UNITED STATES PATENT AND TRADEMARK OFFICE

APPLICATION NO.	FILING DATE	FIRST NAMED INVENTOR	ATTORNEY DOCKET NO.	CONFIRMATION NO.
10/623,933	07/21/2003	James C. Smith		6471

Office Action Summary

DETAILED ACTION

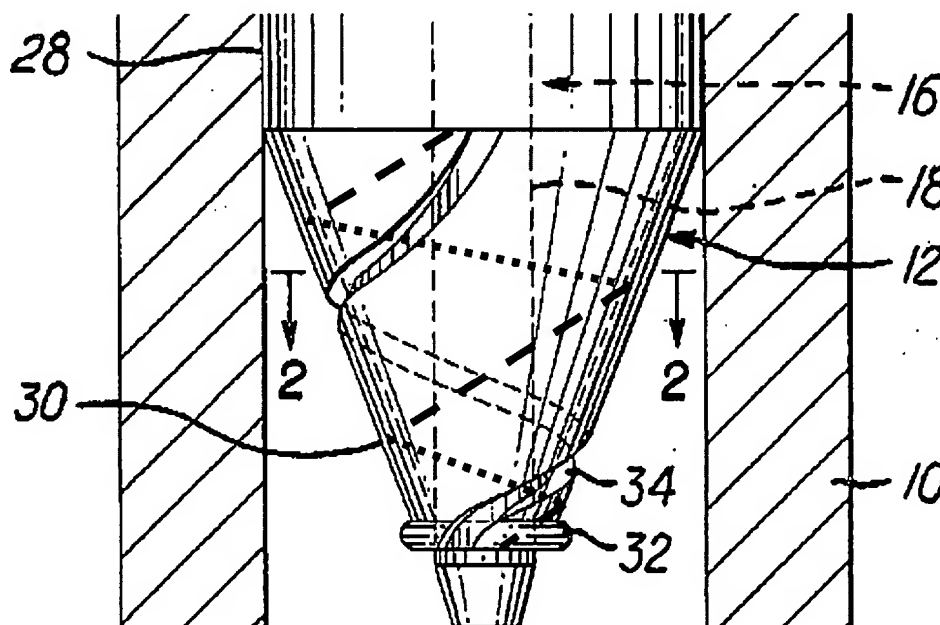
Carluccio '298 teaches a tubular member (10) having an open end, and a wiping cap (12) including a cup-shaped conical wiper, and a frustum (26) for mating with the tubular member. Examiner notes the wiper forms a seal at the apex around the applicator head (22), which alternatively can be read as forming a substantial seal because it tapers to a narrow opening. Also, Examiner notes the wiper appears to make more than one full revolution. See the dotted lines below whereby it appears the wiper

actually makes almost two revolutions. Examiner notes the dashed line represents the frontal path, and the dotted line is the path as it is traced behind the cone. Also, note the very bottom of the line is difficult to see, but can be seen adjacent the line for element (32). Finally, Examiner notes the spiral cut (34) appears to make one full revolution. It is suggested the Applicant amend the claim to better define the structural differences over Carluccio '298 in view of this analysis.

Examiner notes the figure provided above, whereby the dotted lines drawn by Examiner make a complete circumferential loop around the brush, and therefore are in complete circumferential contact. Examiner furthermore notes Applicant's own figures 16-17, whereby it can be seen the pipette is not in complete contact with the entire wiper, only a portion of it, and that Carluccio '298 would appear to function in a similar manner.

Examiner notes the figure provided above, whereby the dotted lines drawn by Examiner make a complete circumferential loop around the brush, and therefore are in complete circumferential contact. Examiner furthermore notes Applicant's own figures 16-17, whereby it can be seen the pipette is not in complete contact with the entire wiper, only a portion of it, and that Carluccio '298 would appear to function in a similar manner.

Examiner notes the reply to Applicants arguments in support of the amendments herein have been clearly addressed in the rejections, and in the figure provided above.
